Summary Highlights of NRC/DOE Technical Exchange and Management Meeting on Pre-Closure Safety

July 24-26, 2001
Las Vegas, Nevada

NRC Item 3(a)-Aircraft Hazards

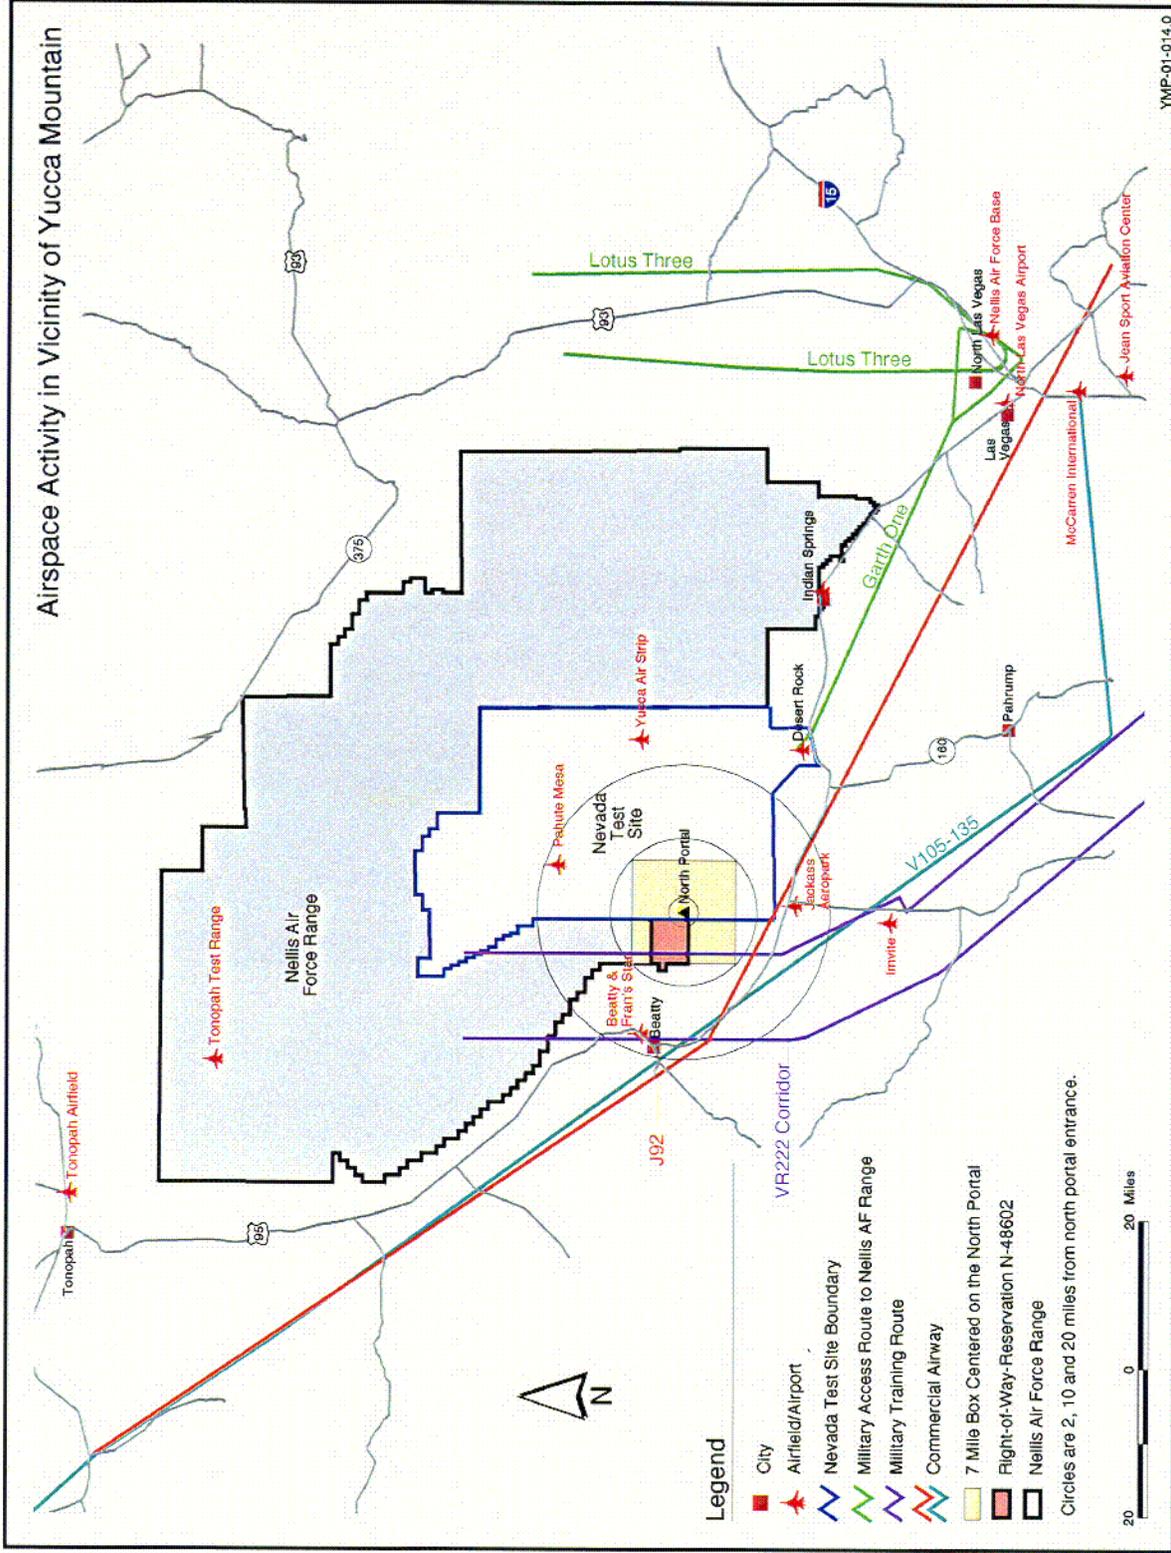
- **NRC Comment**

- **The DOE should provide a detailed analysis of the aircraft crash hazards by taking into consideration all types of aircraft flying in the vicinity of the proposed site**

- **DOE Response**

- **DOE agrees with comment and will develop a vicinity map with aircraft types and activities identified. An evaluation of the aircraft activities within this vicinity will determine which activities will require quantitative crash frequency analysis. DOE is defining vicinity as the area where the flight activity will have an impact on the evaluation of aircraft hazards**
